Technical Information

Air-to-Water

Subject: Air-to-Water Mono-bloc H2O (pump abnormality) Error

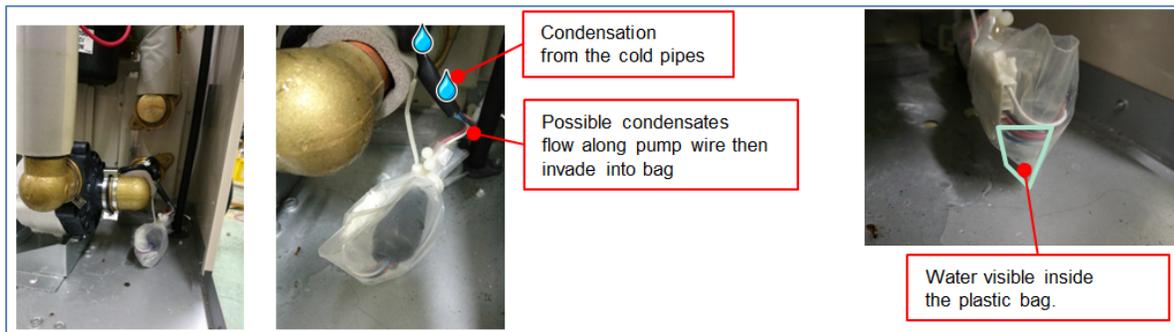
The pump leadwire connector is protected with a plastic bag but in rare cases where environmental conditions cause excessive dew formation inside the unit during cooling mode operation, condensates from cold pipes drop through the opening of the bag and accumulate inside it. This condition could lead to short circuit on the water pump wire connection when electrical power is supplied to the pump. Refer to Figure 1 for details.

When power is supplied constantly to the pump and arc discharge occurs consistently due to the water on the connector, the wire on the pump connector will burn (refer Figure 2) and cause erroneous data to be feedback to the microcontroller about the speed of pump rotation, triggering the H2O alarm.

When this happens, the DC pump and main PCB need to be replaced. To prevent recurrence, ensure the position of the pump connector is as shown in Figure 3 and the countermeasure (refer 3) is implemented.

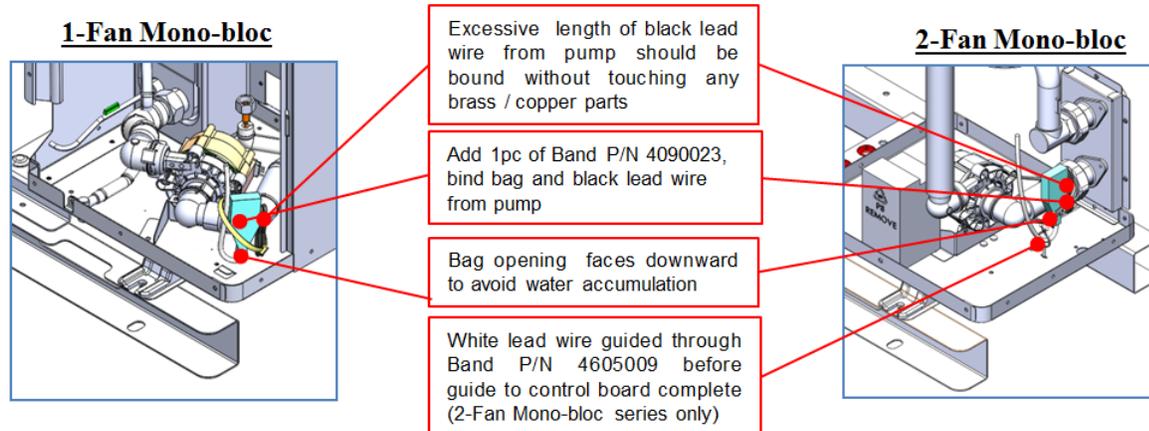
Starting production July 2017, the following changes will be implemented to prevent the condition from happening (refer Figure 3 for illustration):

1. Pump connector wire guiding direction is changed from horizontal to vertical with the opening of the plastic bag facing down towards the chassis to prevent water accumulation inside the bag.
2. Excess length of the pump leadwire and the plastic bag are bound with a band (part number 4090023) without touching any brass or metal parts.
3. For 2 Fan mono-bloc models, the white lead wire is guided through the band (part number 4605009) to the control board.
